THE GOODSYARD

Transport Addendum Note

PROJECT NO. 70040342

DATE: FEBRUARY 2020

Figure 1: Proposed Bethnal Green Road service yard access arrangement

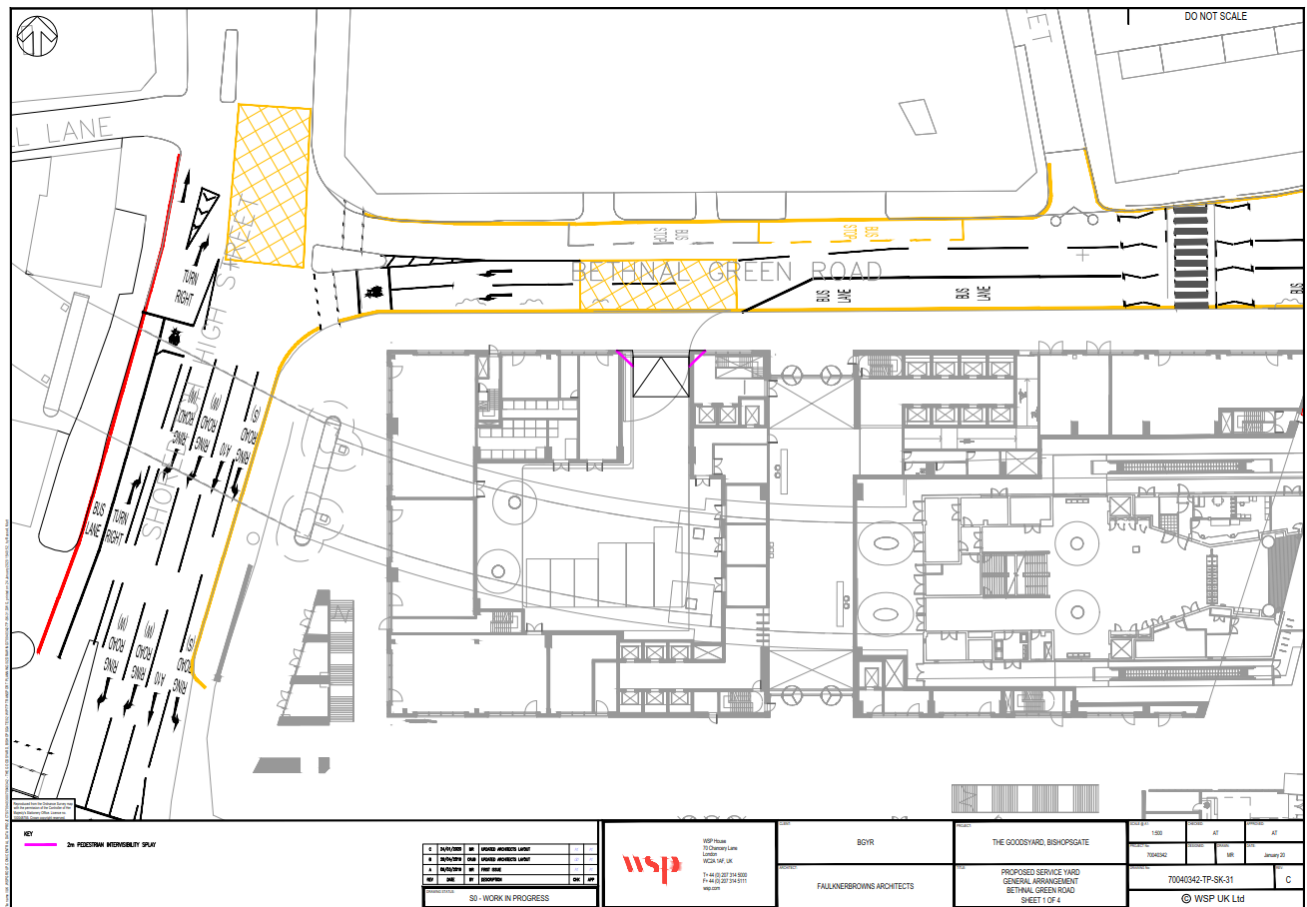
Comment 3. The swept path analysis raises more questions than it answers as the vehicles would impact pedestrian flows along the southern footways along Bethnal Green Road, as

- 2.2.25. The service yard access would require a new vehicle crossover, which would be located approximately 36m east of the stop line at the junction with the A10 Shoreditch High Street. To mitigate the impact on pedestrians moving along the south edge of Bethnal Green Road, it would be proposed to include a raised carriageway on the proposed service yard access to retain the footway level and provide a continuous footway for pedestrians on Bethnal Green Road. The proposed service yard access would be approximately 7.3m in width.

- 2.2.26. With regards to pedestrian safety the proposed service yard access will provide adequate inter-visibility between pedestrians on the south footway of Bethnal Green Road and vehicles entering and exiting the site. The pedestrian inter-visibility splays required are shown in Figure 1.

- 2.2.28. The revised proposals would include extending the westbound bus lane along the south edge of Bethnal Green Road, up to the location of the proposed service yard access. This would reduce the risk of left-turning vehicles into the site obstructing westbound buses. This proposal should be discussed further with TfL, London Buses, and the Boroughs, as it would reduce queuing space for general traffic westbound on Bethnal Green Road.

- 2.2.29. The revised proposals would also include the provision of a yellow box markings in the westbound lane on Bethnal Green Road, to ensure right-turn manoeuvres into and out of the site are not impeded by westbound queuing traffic on Bethnal Green Road.

- 2.2.31. Figure 1 shows the proposed service yard access on Bethnal Green Road, including the revised proposals described above.

Figure 4: Revised service yard access on Braithwaite Street for Plots 2 & 8

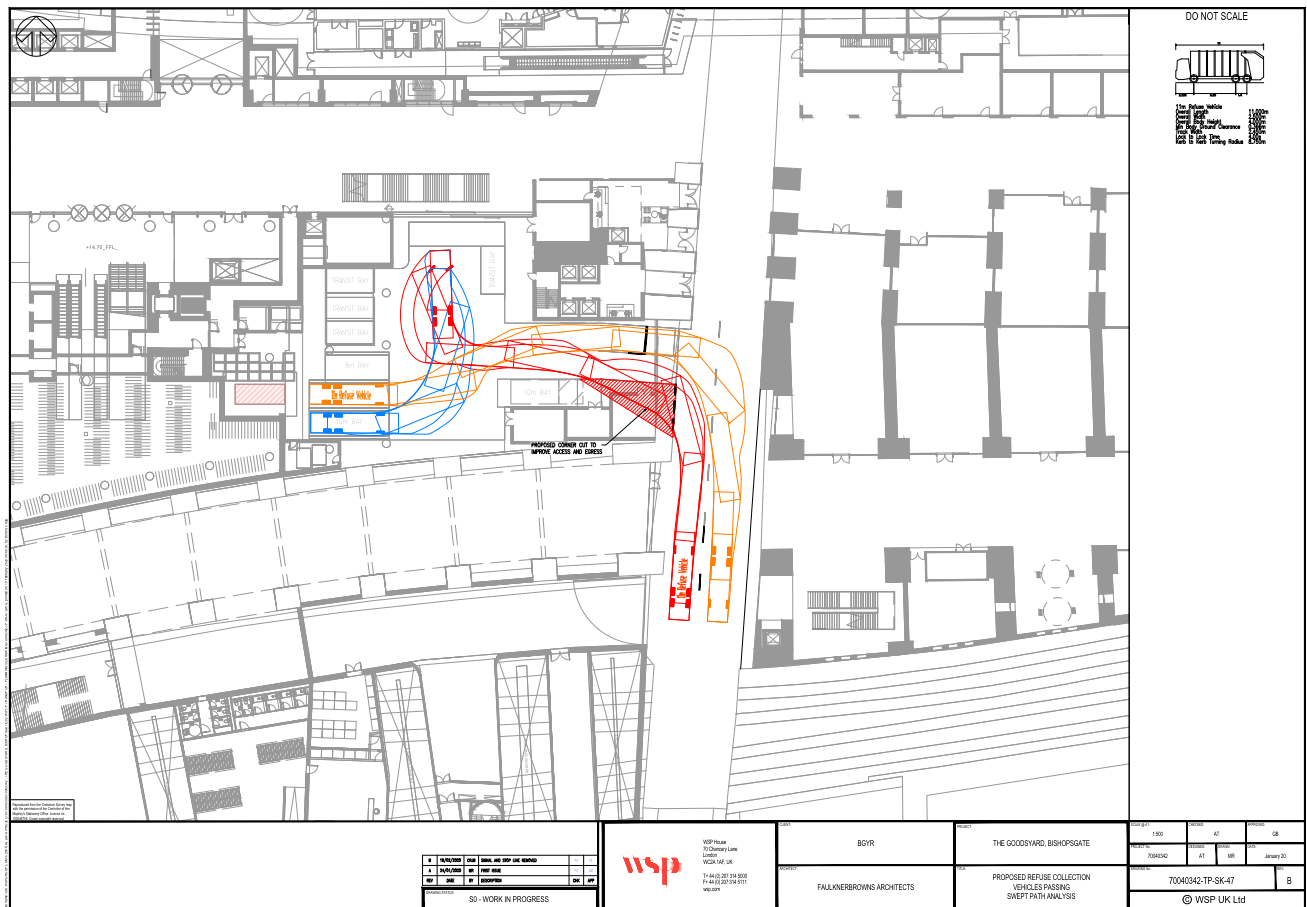
Comment 7. Access to the yard is not wide enough to allow two-way movement and so traffic signals are proposed on the public highway to hold vehicles in order for another vehicle to exit the site. Whilst a vehicle is held at the lights, together with the tracking movement of the vehicle exiting the site would take up the whole of the available highway and is considered to be a safety issue for pedestrians and cyclists.

This level of servicing is considered unacceptable in terms of the nature of this street and the amenity of existing residents in the locale. The street would in effect become an extension of the servicing area.

- 2.4.18. In response to the comments received from the Boroughs and TfL, the proposed service yard access will be widened to approximately 13m to accommodate two-way service vehicle movements at the access, as shown in Figure 4.

- 2.4.19. To avoid servicing vehicles waiting on the Braithwaite Street carriageway, vehicles entering the site will be given priority, which would be regarded as an improvement on the previous proposals.

Figure 5: Swept path assessment at junction between Wheler Street and Commercial Street

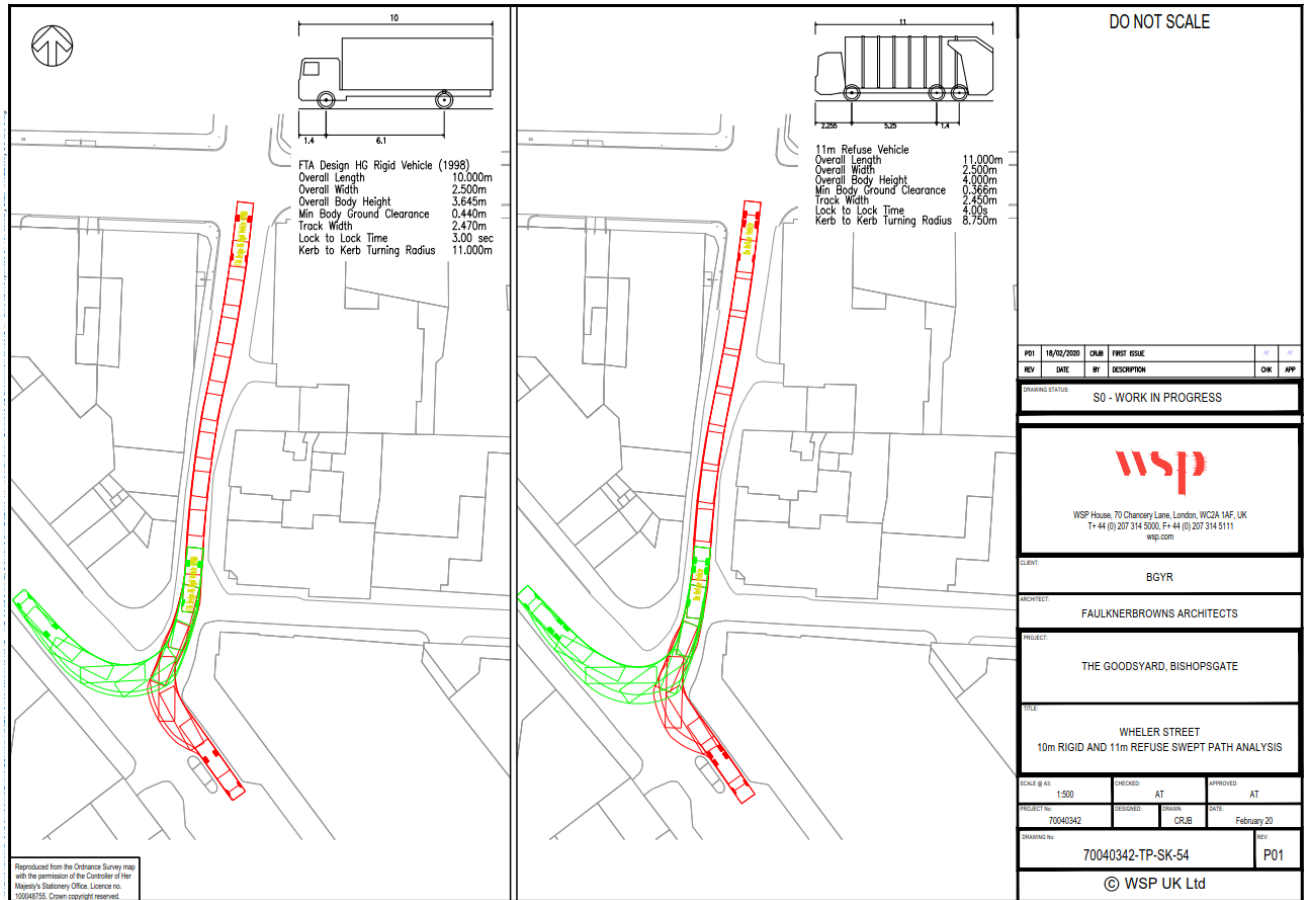
- 2.4.23. LB Tower Hamlets has requested a swept path assessment showing servicing vehicles southbound on Braithwaite Street / Wheler Street, after exiting the service yards, in particular the turning movement at the junction with Wheler Street and Commercial Street.

- 2.4.24. Figure 5 shows a 10m HGV and an 11m refuse vehicle southbound on Wheler Street, turning out left and right onto Commercial Street.

2.4.25. Figure 5 shows the manoeuvre for both vehicles would be feasible.

Figure 8: Previously proposed accessible parking on-site (Figure 9.6 in Goodsyrd Transport Assessment, September 2019)

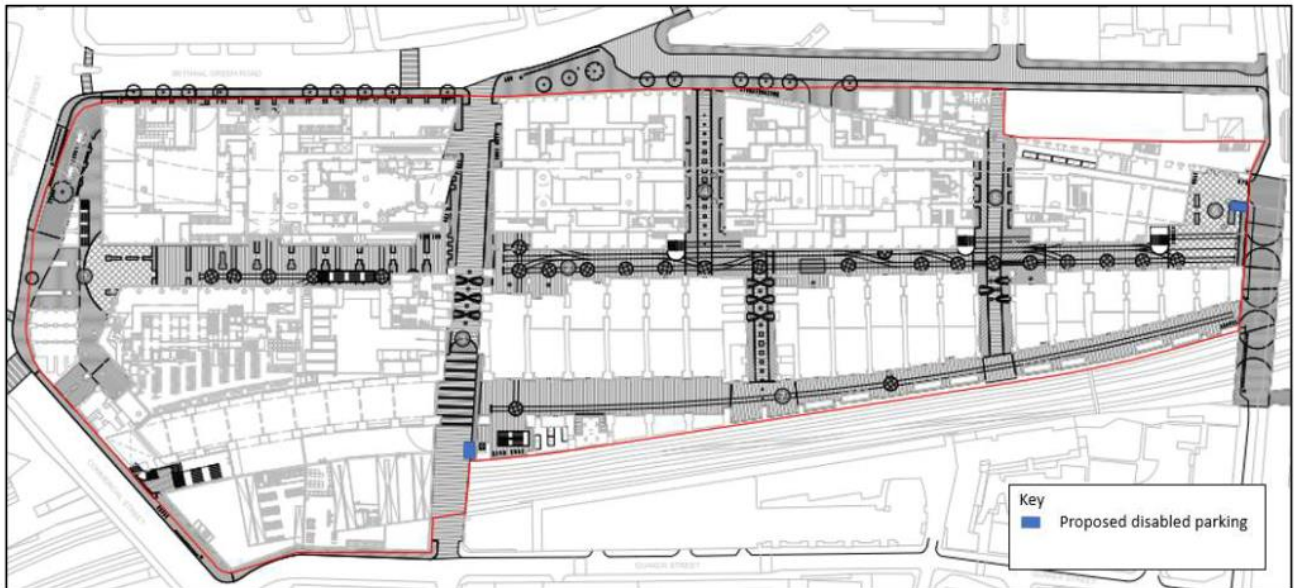
Comment 14. The applicant is proposing very few accessible parking spaces on site and this is considered unacceptable and at odds with current recommendations on other developments within LBTH and LBH.

- 2.6.2. Section 9.5 in The Goodsyrd Transport Assessment (September 2019) outlined the car parking proposals. The proposed development will be car-free with the exception of accessible parking provision.
- 2.6.3. The proposals submitted as part of the application, shown in Figure 8, included two on-site accessible bays for each of the proposed uses for the Detailed Component of the application, office (Plot 2) and retail (Plot 7). The location of the accessible parking bays are shown next to Braithwaite Street and Brick Lane, as shown in Figure 8.

- Plot 4 – 144 residential units
 - Plot 5 – 84 residential units
 - Plot 8 – 138 residential units
 - Plot 10 – 134 residential units
- 2.6.7. An accessible parking provision at 3% would equate to 15 accessible bays. Figure 9 shows the revised proposals for accessible parking on-site, showing the location of the 15 accessible bays. The parallel accessible parking bays would be approximately 6.6m in length and 2.7m in width.

Figure 10: Proposed cycle parking (Figure 9.4 in Goodsyard Transport Assessment, September 2019)

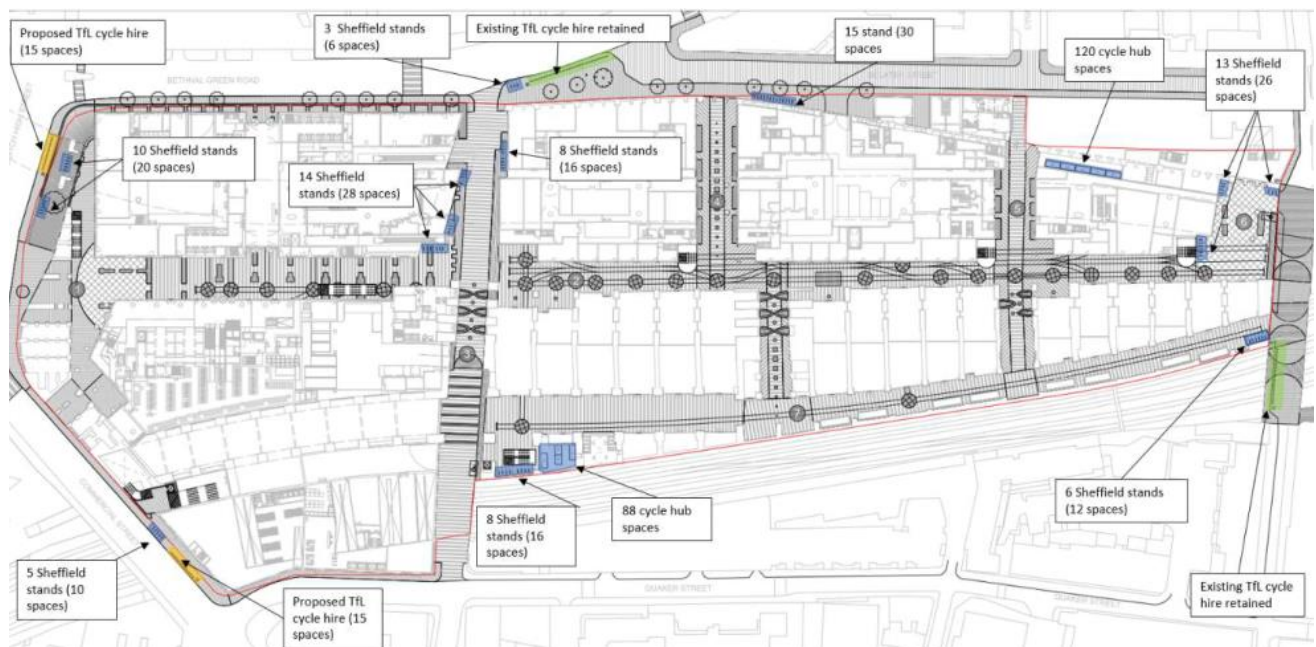
3.2.3. At the meeting on 05 December 2019, the TfL officer in attendance highlighted some concerns with the previous proposals which included:

- Cycle hire at The Goodsyard site would be expected to experience tidal-use which would need to be managed and redistributed;
- It was noted the revised Goodsyard scheme proposed fewer TfL cycle hire spaces than the previous scheme;
- TfL would prefer to see two new docking stations, with 25 cycle hire spaces in each;
- The new docking stations would require access by a 7m long vehicle for the redistribution of cycles; and
- The proposed docking stations would preferably be provided on-site.

- 3.2.5. It has been agreed for the current planning application, a Section 106 contribution will be made to provide the new docking stations, however TfL would like to see where the docking station spaces would be provided on or around the site.
- 3.2.6. A subsequent meeting on-site was arranged with the Boroughs and TfL to discuss suitable locations for additional TfL cycle hire docking stations, which is addressed in the next chapter of the note.

Figure 11: Pinch points on south section of Braithwaite Street

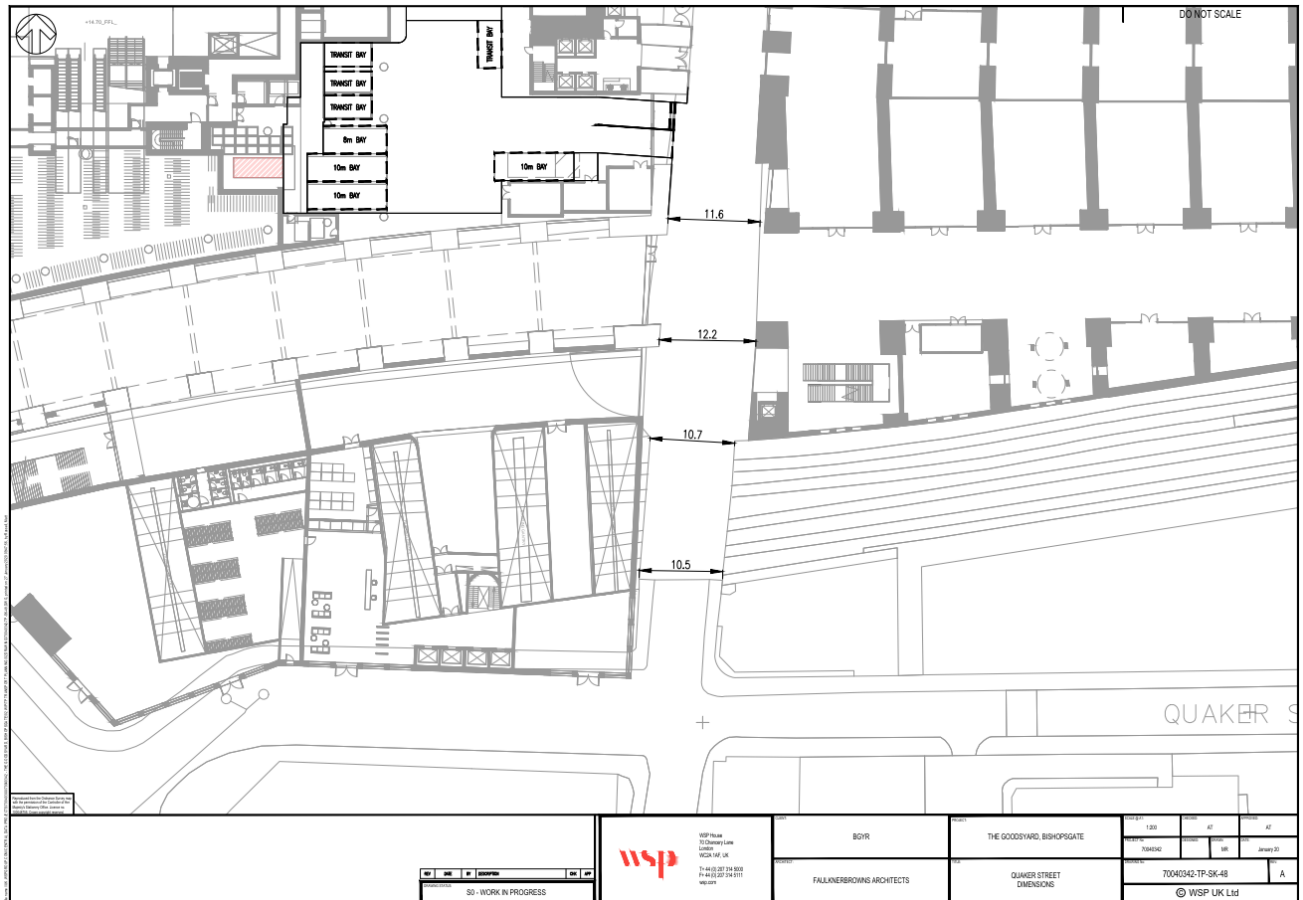
- Vehicles currently observed stopping on the north edge of Bethnal Green Road, opposite the proposed servicing yard access, which should be considered;
- Requested further justification of the location of the proposed servicing yard access on Bethnal Green Road;
- Requested a broader plan of pedestrian movements in and round the site;
- Braithwaite Street service yard access cannot accommodate two-way movements, and vehicle movements take up the full width of Braithwaite Street;
- Feasibility of greater use of the Bethnal Green Road servicing yard;
- Consideration of measures to reduce the volume of servicing trips, including use of cargo bikes and electric vehicles;
- Requested further details of interaction between servicing vehicles, pedestrians, and cyclist on Braithwaite Street;

- 3.5.15. With regard to the details of the interaction between servicing vehicles, pedestrians, and cyclist on Braithwaite Street, Comment 9 in Section 2.4 has outlined the street widths which are repeated below.

- 3.5.16. The proposed wall to wall widths on Braithwaite Street have been identified below, and shown in Figure 11:
 - South edge of Braithwaite Street bridge – 10.50m

- North edge of Braithwaite Street bridge – 10.70m
 - North edge of London Road – 12.20m
 - South of proposed Plot 2 & 8 service yard access – 11.60m

- 3.5.17. Assuming the service vehicles are approximately 2.5m in width, two vehicles passing one another would require a carriageway width of approximately 6m. At the narrowest point, at the south edge of the Braithwaite Street bridge, a width of 4.50m would be available for pedestrians, a width of 2.25m on either side of the carriageway.
- 3.5.18. It is assumed cyclist would use the 6m two-way carriageway on Braithwaite Street, with pedestrians using the pedestrian areas along the edge of the road.
- 3.5.19. It is proposed the layout and design of Braithwaite Street would be coordinated through discussions and design workshops with LB Tower Hamlets as the Highway Authority.
